**IPCC Synthesis Report
Fourth Assessment Report**

Formal Government and Expert Review of First Order Draft

EXPERT and GOVERNMENT COMMENTS – SPM

All Batches (July 27, 2007)

Reference to Running Number SPM-2 (Comment Number E-SPM-2-A):

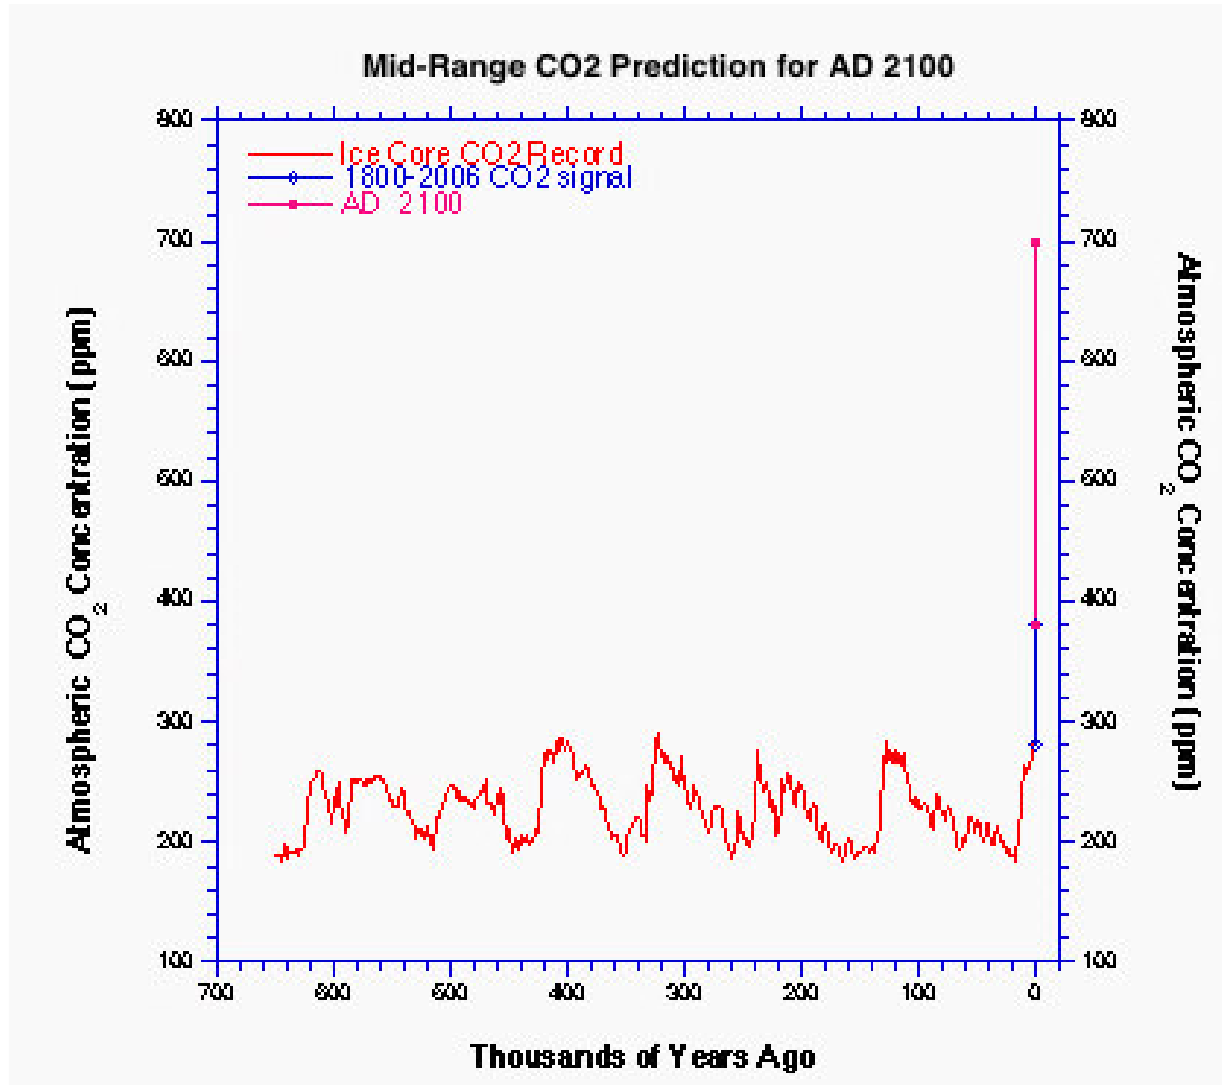
Executive Summary for Policymakers

Reference to Running Number SPM-1675 (Comment Number E-SPM-953-A):

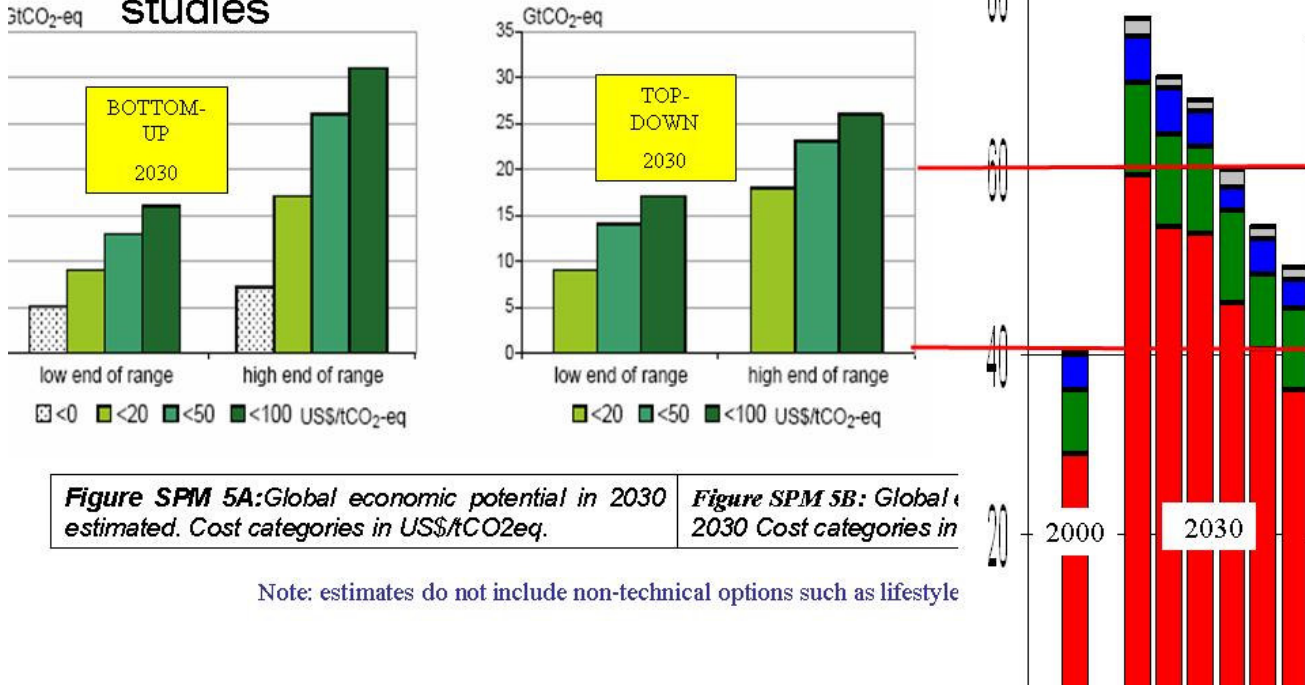
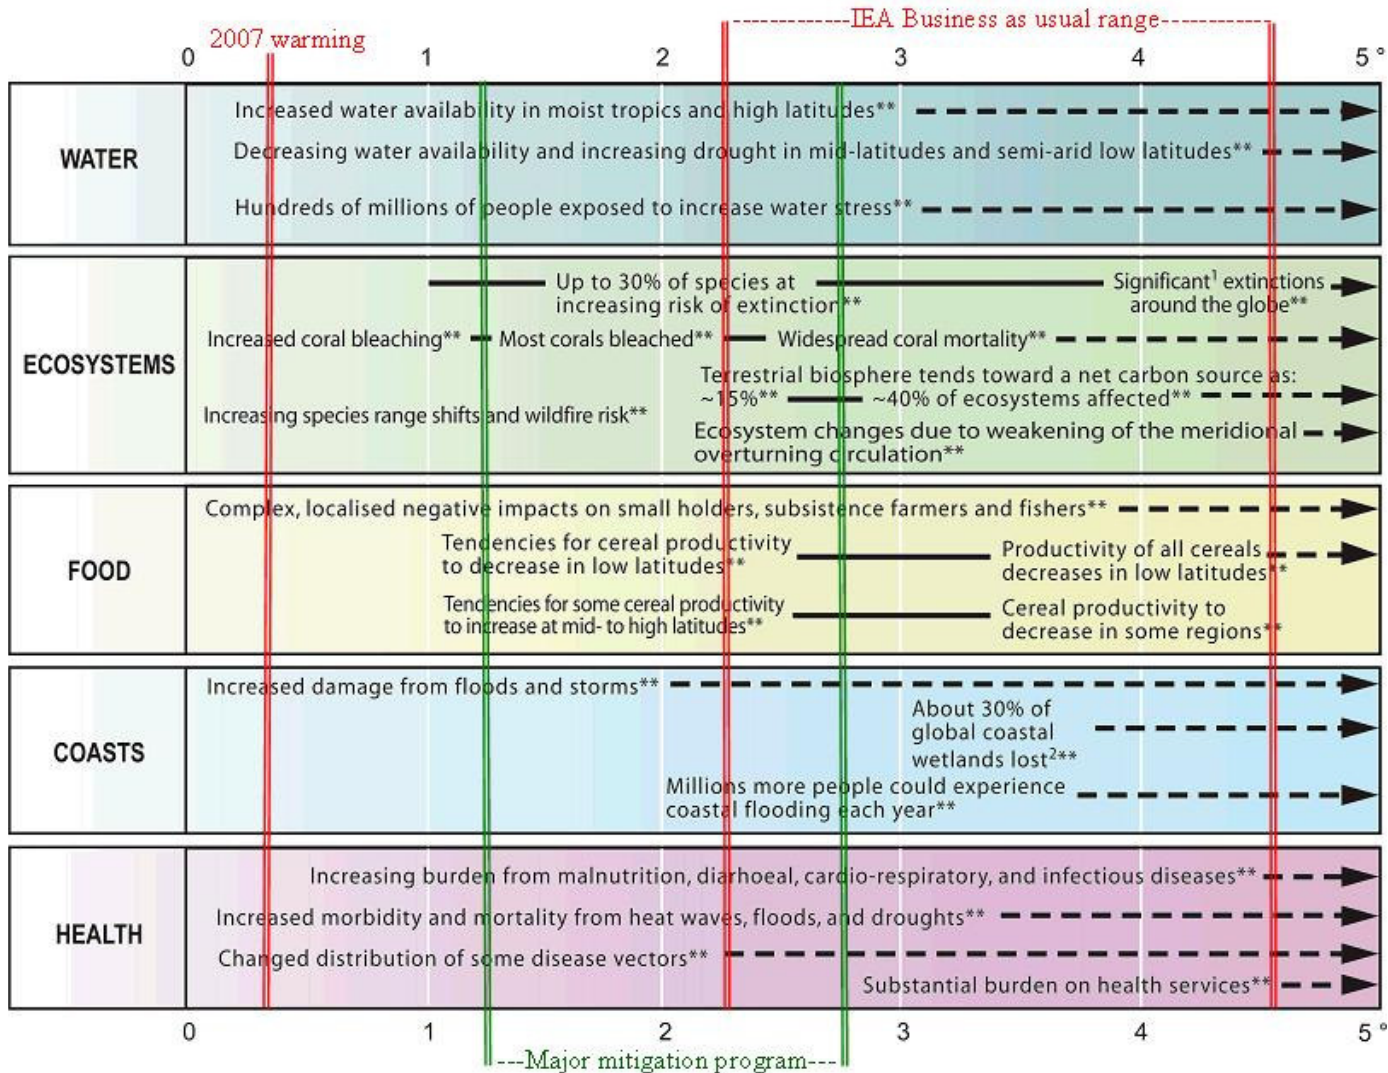
Economic potential is substantial for the mitigation of global GHG emissions over the coming decades

- Estimates are from both bottom-up and top-down studies
